Crystal River Nuclear Plant
Docket No. 50-302
Operating License No. DPR-72

Subject: Crystal River Unit 3 – Response to Request for Additional Information for the Review of the Crystal River Unit 3 Nuclear Generating Plant License Renewal Application (TAC NO. ME0274) – and Amendment #6

RESPONSE TO REQUEST FOR ADDITIONAL INFORMATION

**AMENDMENT #6
CHANGES TO THE LICENSE RENEWAL APPLICATION**

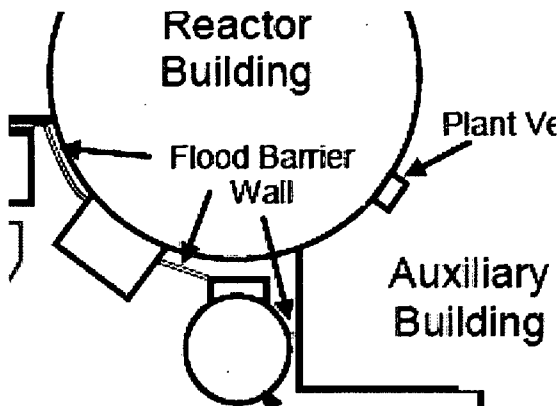
Source of Change	License Renewal Application Amendment #6 Changes						
RAI 2.4.2.1-1	<p>For Auxiliary Building stainless steel "Platforms, Pipe Whip Restraints, Jet Impingement Shields, Masonry Wall Supports, and Other Miscellaneous Structures" in Table 3.5.2-2, on LRA page 3.5-76, add the following line item to address Air - Outdoor:</p> <table><tr><td>Air - Outdoor</td><td>Loss of Material</td><td>Structures Monitoring</td><td>III.B4-7 (TP-6)</td><td>3.5.1-50</td><td>C, 532</td></tr></table>	Air - Outdoor	Loss of Material	Structures Monitoring	III.B4-7 (TP-6)	3.5.1-50	C, 532
Air - Outdoor	Loss of Material	Structures Monitoring	III.B4-7 (TP-6)	3.5.1-50	C, 532		
RAI 2.4.2.3-1	<p>To update the status of the Door (Non-Fire) in the BWST Foundation and Shield Wall structure, delete the last sentence of the first paragraph of Subsection 2.4.2.3 on page 2.4-15. Also, on page 2.4-15, revise the second sentence under <u>FSAR and Drawing References</u> to read:</p> <p>FSAR Section 5.1.1.1 identifies the structure itself as Class I.</p> <p>Delete Intended Function C-8 from the Component/Commodity "Doors (Non-Fire)" on both Table 2.4.2-3 on page LRA 2.4-16 and Table 3.5.2-4 on page 3.5-83.</p> <p>On LRA Figure 2.2-1, revise the Flood Barrier Wall between the BWST and the Reactor Building to agree with the following sketch:</p> 						
RAI 4.5-1	<p>Replace Tables 4.5-1, 4.5-2, 4.5-3, and 4.5-4 on LRA pages 4.5-3 through 4.5-10 with the corresponding following tables.</p>
